Project: 201004sid-N169770 JHHIP Stage 1 SSDA report - 2036 without Dev

C. COMPLIANCE REVIEW

HEALTH INFRASTRUCTURE
JOHN HUNTER HOSPITAL NEWCASTLE
BASEMENT 01
CAR PARK COMPLIANCE REVIEW
DRAWING NO. N169772-01-02 SHEET 02 OF 12 ISSUE P3

DRAWING NO. N16972-01-01

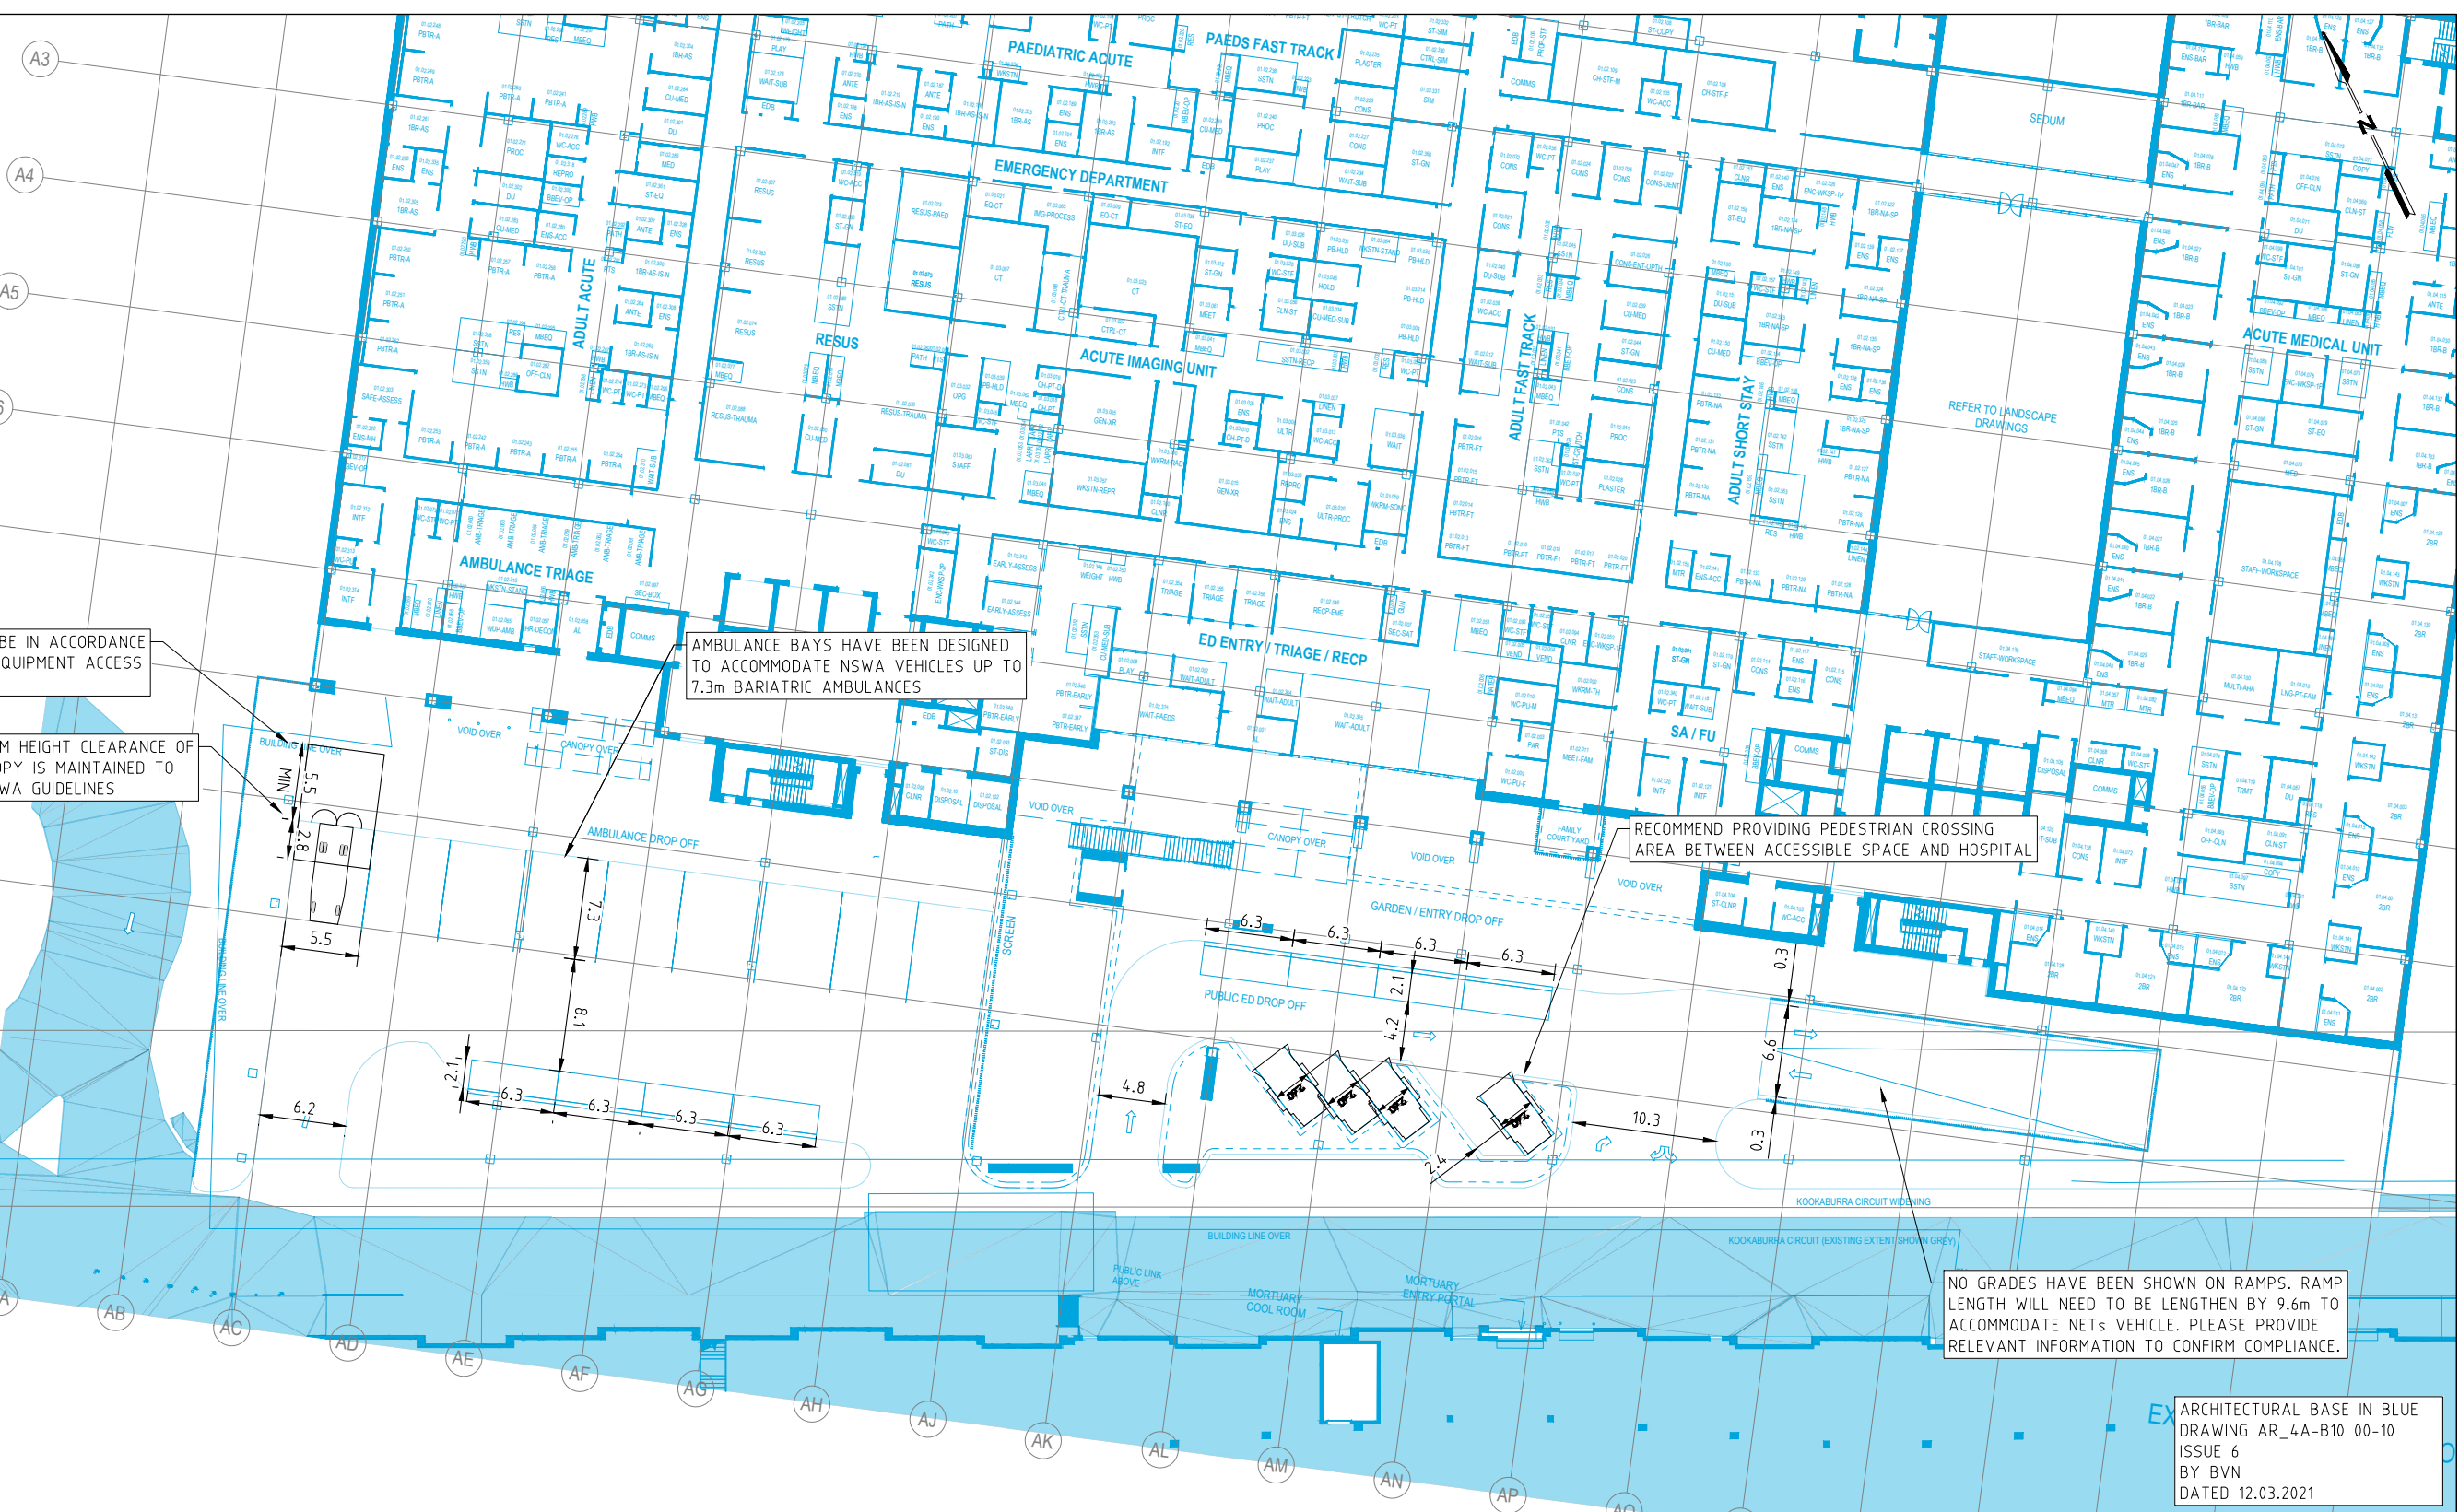
NO GRADES HAVE BEEN SHOWN ON RAMPS. RAMP LENGTH WILL NEED TO BE LENGTHEN BY 9.6m TO ACCOMMODATE NETS VEHICLE. PLEASE PROVIDE RELEVANT INFORMATION TO CONFIRM COMPLIANCE.

CONVERT BAYS TO PROVIDE TWO 2.6m WIDE AND ONE 2.4m CAR BAYS FOR 0.3m CLEARANCE TO STRUCTURE IN THE DOOR OPENING ZONE

RECOMMEND MODIFICATIONS AS PER PREVIOUS ADVICE (N169772-01-P1). CURRENT ARRANGEMENT MAY PREVENT VEHICLES TO ENTER CAR PARK DURING PEAK EXIT PERIODS WHERE QUEUES EXTEND.

CONVERT BAYS TO PROVIDE TWO 2.6m WIDE AND ONE 2.4m WIDE SMALL CAR BAYS FOR 0.3m CLEARANCE TO STRUCTURE IN THE DOOR OPENING ZONE

RECOMMEND KERB MODIFICATION

PROPOSED KERB MODIFICATIONS

RAMP LOCATION FROM GROUND LEVEL SHOWN IN GREEN. ENSURE RAMP ALIGNS WITH GROUND PLANS.

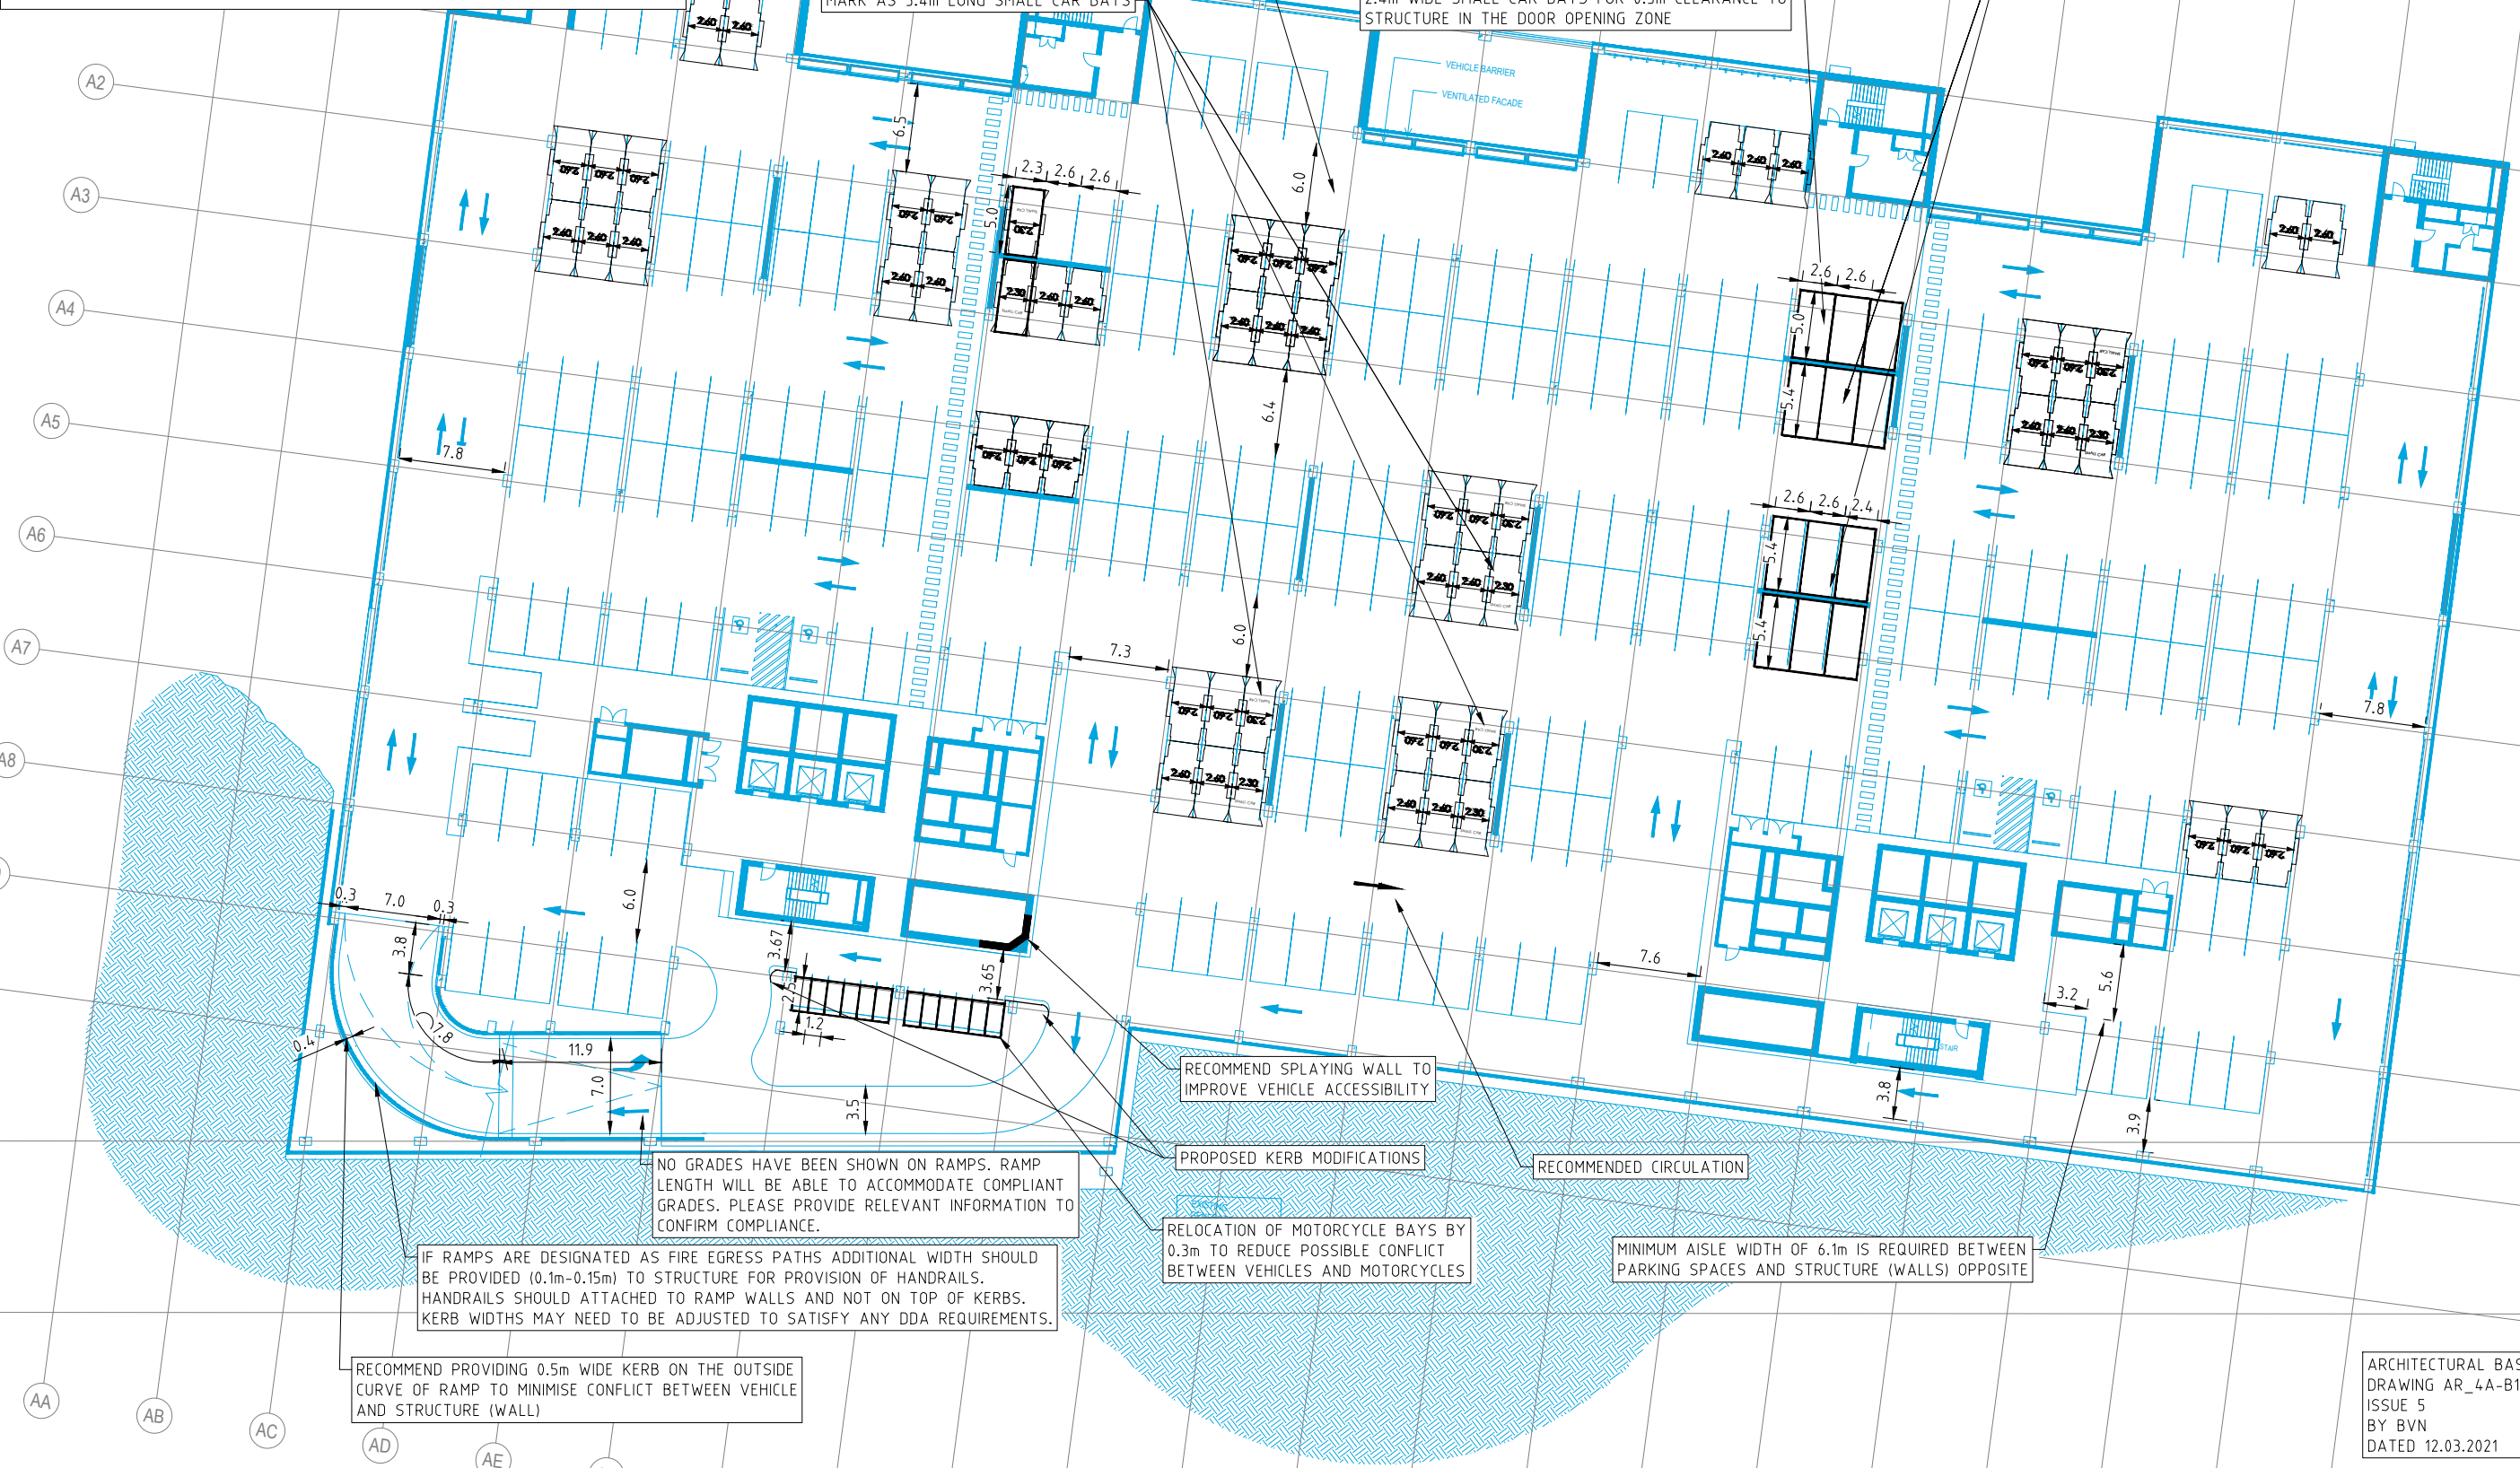
NO GRADES HAVE BEEN SHOWN ON RAMPS. RAMP LENGTH WILL NEED TO BE LENGTHEN BY 6.7m TO ACCOMMODATE NETS VEHICLE. PLEASE PROVIDE RELEVANT INFORMATION TO CONFIRM COMPLIANCE.

SPEED HUMPS ALONG CIRCULATION AISLE WILL BE REQUIRED, TO BE CONFIRMED IN DETAILED DESIGN

CONVERT BAYS TO PROVIDE TWO 2.6m WIDE AND ONE 2.4m WIDE SMALL CAR BAYS FOR 0.3m CLEARANCE TO STRUCTURE IN THE DOOR OPENING ZONE

CONVERT BAYS TO PROVIDE TWO 2.6m WIDE AND ONE 2.4m CAR BAYS FOR 0.3m CLEARANCE TO STRUCTURE IN THE DOOR OPENING ZONE
